April 17, 2012

Si4x3x Errata (rev. B)

Errata Status Summary

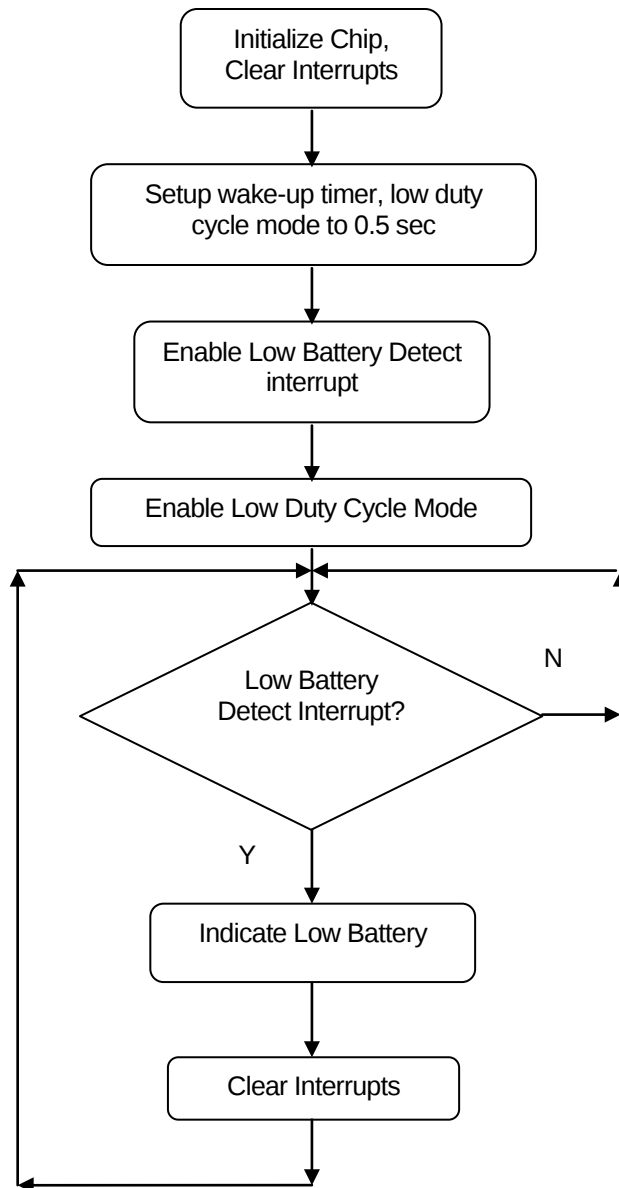
3. **Description:** This issue **ONLY** affects SLEEP mode when the low battery detection (LBD) function is ENABLED (enlbd = 1 in Register 07h). Note that the LBD function is DISABLED by default.

If LBD is ENABLED, approximately 5% of devices will enter into a state that draws more current than expected in SLEEP mode. Such devices will draw an average current of approximately 350 µA in SLEEP mode versus the expected 1 µA. These devices will also report an inaccurate battery voltage level in SLEEP mode.

The cause of the issue has been verified to be the improper reset of the LBD circuitry when in SLEEP mode.

Impact: Affected devices will draw more current than expected in SLEEP mode which will reduce the battery life of battery-backed products.

Workaround A: This workaround utilizes the Low Duty Cycle Mode function of the device to periodically check the battery level. The wake-up timer (WUT) period must be set in conjunction with the LDC mode on time to 0.5 s for this workaround to function properly. It does not require any intervention by an external MCU. The average current when using this workaround is 2.5 μ A.
